BULLETIN # 3 6

PROJECT: Harrison Recreation & Community Center – PHASE 2
Harrison, NY

RE: Site Plan Revisions

ASK-39

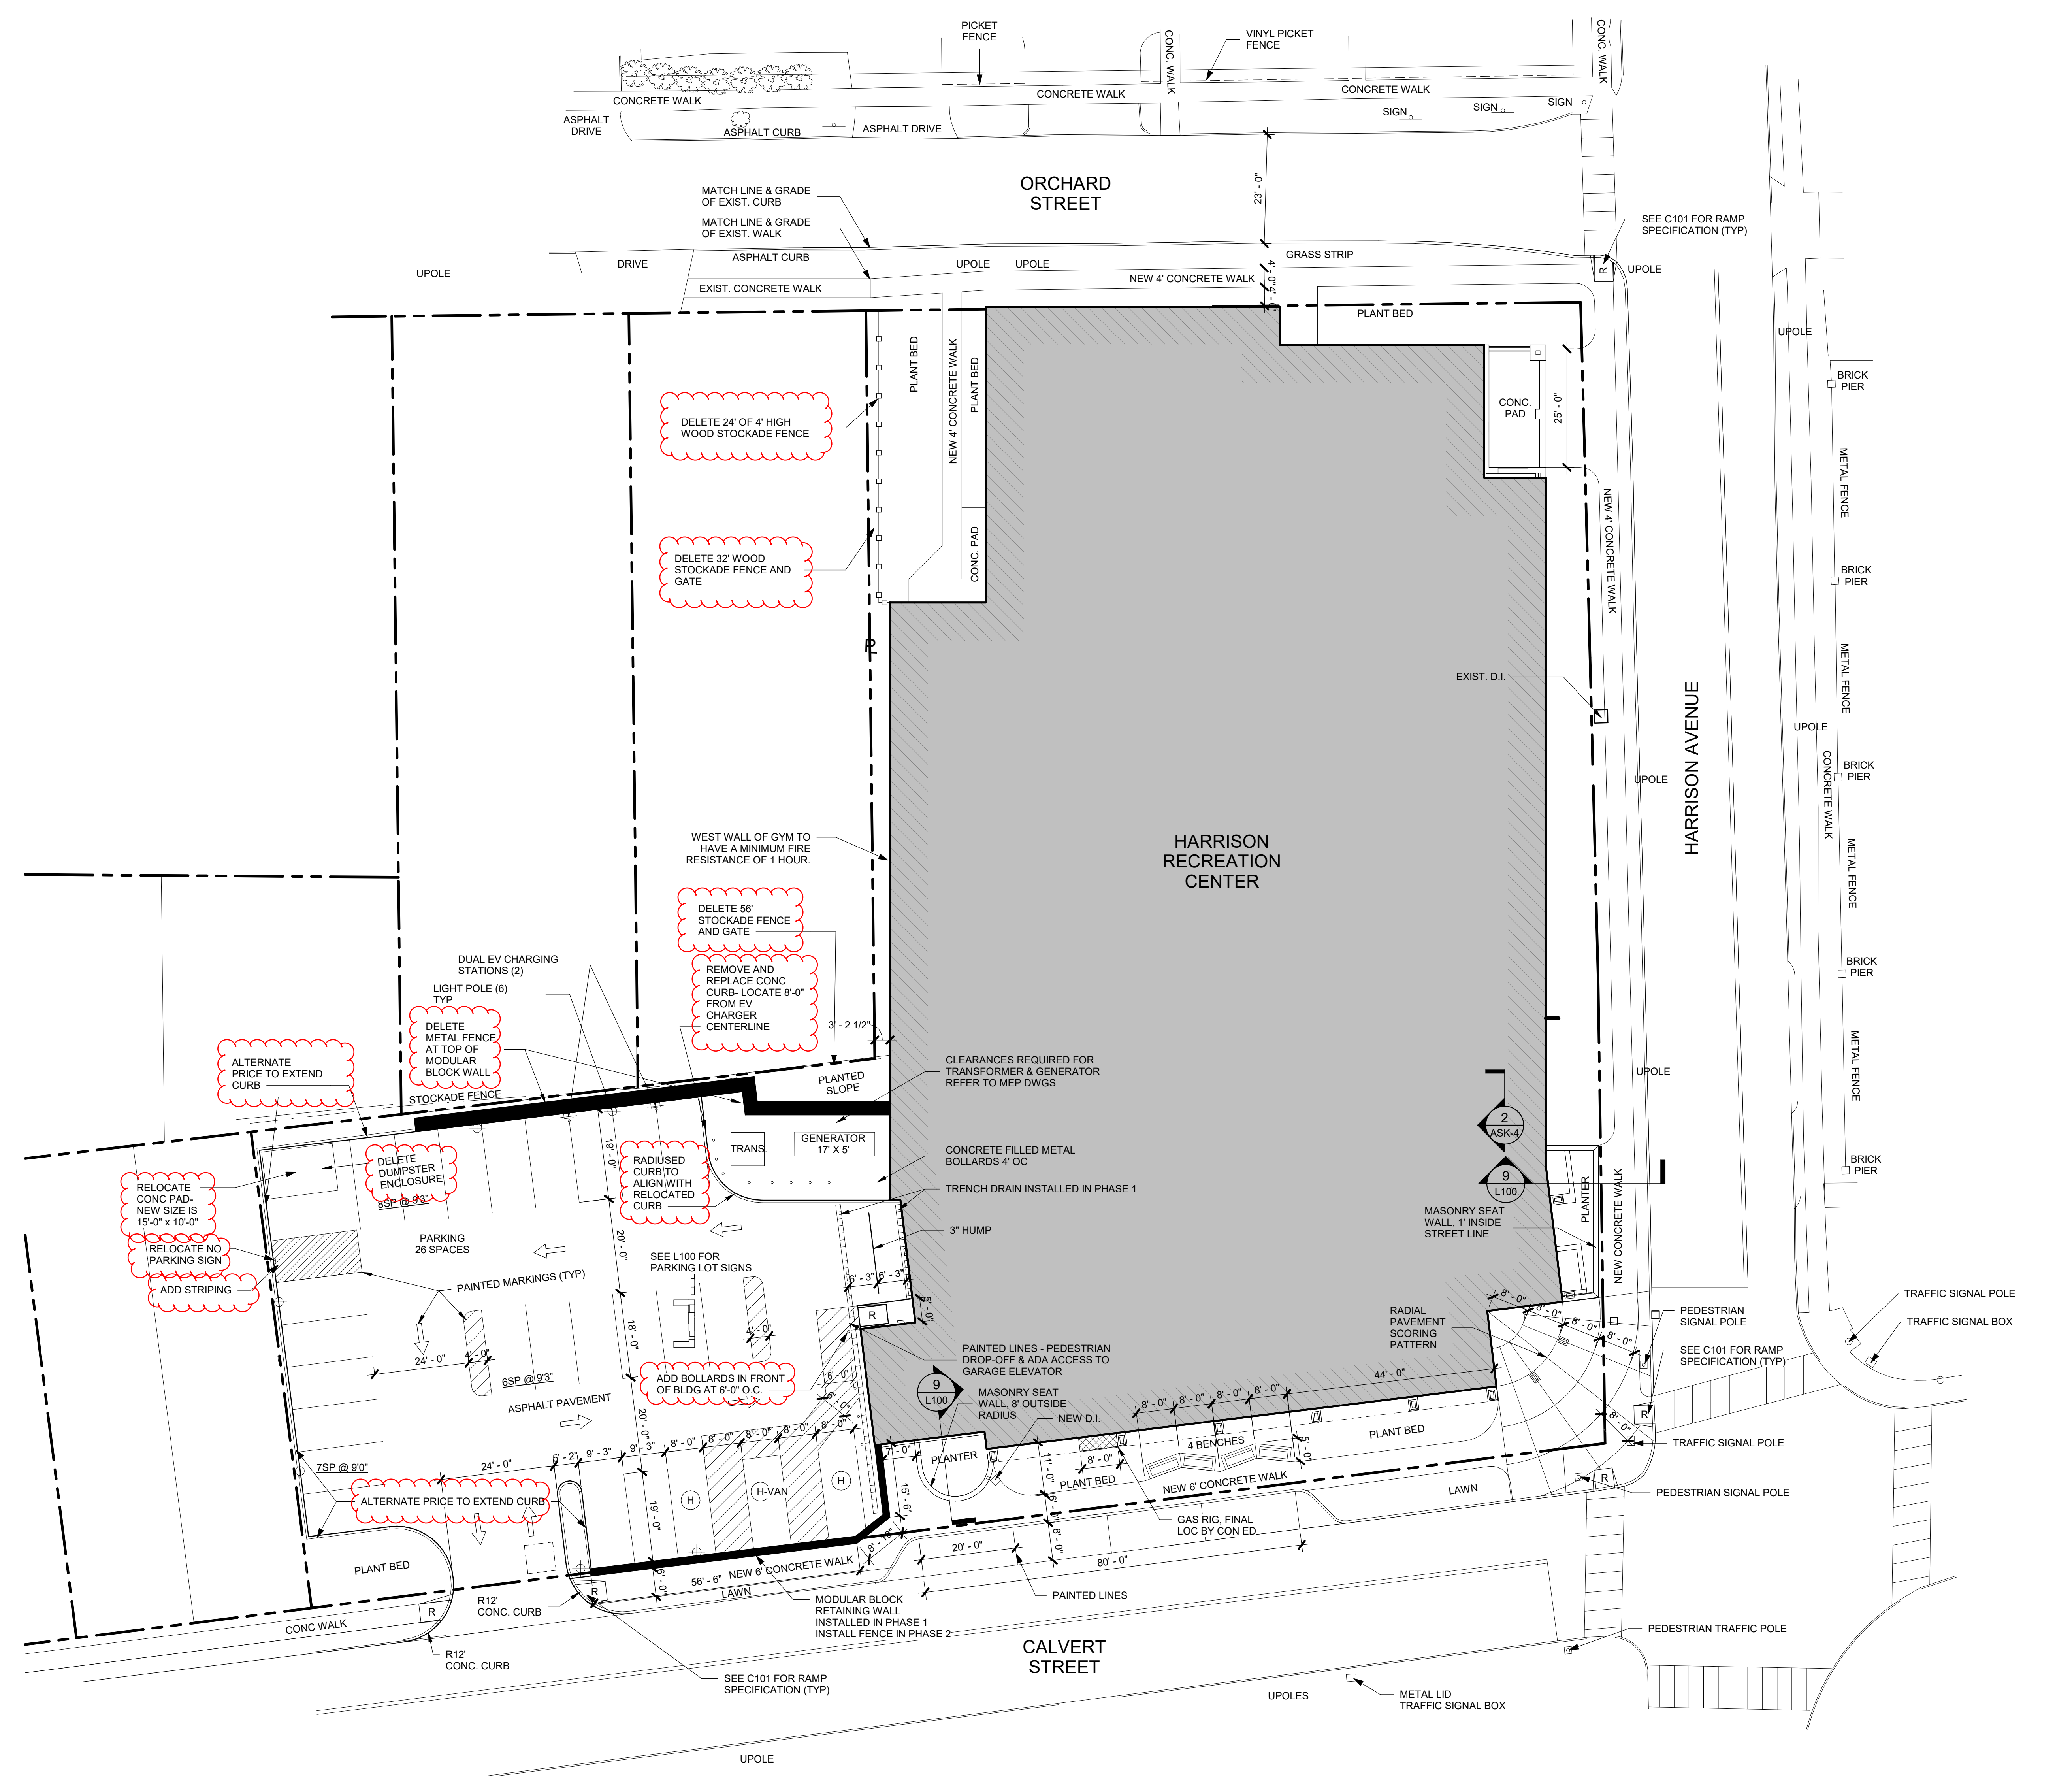
See attached ASK-39 for revisions to the Site Plan. The wood stockade fence and gates are deleted. The dumpster enclosure is deleted. The railing at the top of the modular block wall at the north side of the parking lot is deleted. Bollards are added in front of the building at the exterior side of Stair A. Add striping in front of the dumpster pad. Relocate pad to corner and re-size the concrete dumpster pad to be 15' x 10'. Remove and relocate the curbing at the transformer to be 8' from the centerline of the first EV charger including the radiused portion. Provide alternate pricing to extend the curbing into the NW corner of the parking lot, along the west side of the lot and at the islands on either side of the entry.
